UNITED STATES PATENT AND TRADEMARK OFFICE

10/589,964

Office Action Summary	Application No. 10/589,964	Applicant(s) KLEIN ET AL.	
	Examiner MADELINE GONZALEZ	Art Unit 1797

DETAILED ACTION

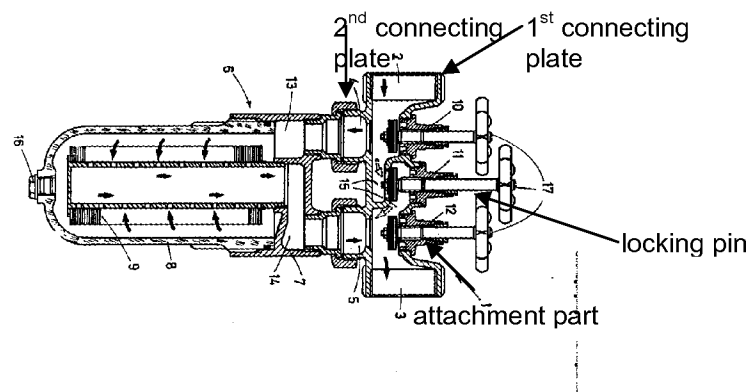
Claims 11, 13-21 and 23 are finally rejected under 35 U.S.C. 102(b) as being anticipated by Nichtnennung (DE 3100499A1).

With respect to **claim 11**, Nichtnennung discloses a filter device, as shown in Fig. 1, having:

- a filter housing 6 having first and second fluid connections and an exterior surface;
- a filter element 9 held in said filter housing 6;
- a fluid container having an exterior surface, said fluid container being the element connected to the filter device (not shown), and
- a connector 1 coupling said fluid connections to said fluid container, said connector 1 having at least one longitudinally displaceable blocking part 10, 11, 12, blocking said fluid connections in a blocking position thereof and opening said fluid connections in an open position thereof, said blocking part 10, 11, 12,

being located between and accessible from said exterior surfaces of said filter housing 6 and said fluid container when said filter housing 6 and said fluid container are coupled by said connector 1.

With respect to **claim 13**, Nichtnennung discloses wherein said blocking part 10, 11, 12, includes a plate-shaped sliding valve part guided for movement between and sealed between first and second connecting plates of said connector 1 by seals facing said filter housing and facing said fluid container, as shown in the figure below.

With respect to **claim 14**, Nichtnennung discloses wherein said fluid connections include a fluid inlet and a fluid outlet in said filter housing 6; said connecting plates include fluid passages corresponding to and forming part of said fluid connections; and said blocking part 10-12 has wall parts that cover said fluid connections in the blocking position and clear said fluid connections in the open position, as shown in Fig. 1.

With respect to **claim 15**, Nichtnennung discloses wherein said fluid inlet and said fluid outlet are located one of top of another in a direction of a longitudinal axis of said filter housing 6, as shown in the figure above; said fluid passages are located one on top of another in said direction of said longitudinal axis; and said blocking part 10-12 has clearance openings 15 between said wall parts, said clearance openings 15 being aligned and congruent with said fluid passages in the open position to convey fluid therethrough, as shown in Fig. 1.

With respect to **claim 16**, Nichtnennung discloses wherein said first and second fluid connection has first and second valves 10-12, respectively, as shown in Fig. 1.

With respect to **claim 17**, Nichtnennung discloses wherein said first fluid connection includes a fluid outlet 14 of said filter housing 6, with said first valve 12 having a valve disk located on an outside of and over said fluid outlet 14; and said fluid connection includes a fluid inlet 13 of said filter housing 6, with said second valve 10 having a valve disk integrated within said filter inlet 13, as shown in Fig. 1.

With respect to **claim 18**, Nichtnennung discloses wherein said filter connections of said filter housing 6 are encompassed on an outer peripheral side thereof by an attachment part; and said connector 1 has flange parts on a connecting plate thereof facing said attachment part, said connecting plate having fluid passages therein encompassed by said flange parts, as shown in the figure above.

With respect to **claim 19**, Nichtnennung discloses wherein said attachment part includes a locking part received in an opening in one of said flange parts and in a recess in said blocking part 10-12 in the open position, as shown in Fig. 1.

With respect to **claim 20**, Nichtnennung discloses wherein said locking device includes a locking pin, as shown in the figure above.

With respect to **claim 21**, Nichtnennung discloses wherein each of said filter housing 6 and said blocking part 10-12 include a handle for manual operation thereof, as shown in Fig. 1.

With respect to **claim 23**, Nichtnennung discloses wherein said blocking plate 10-12 moves translaterally between the blocking and open positions, as shown in the figure above.
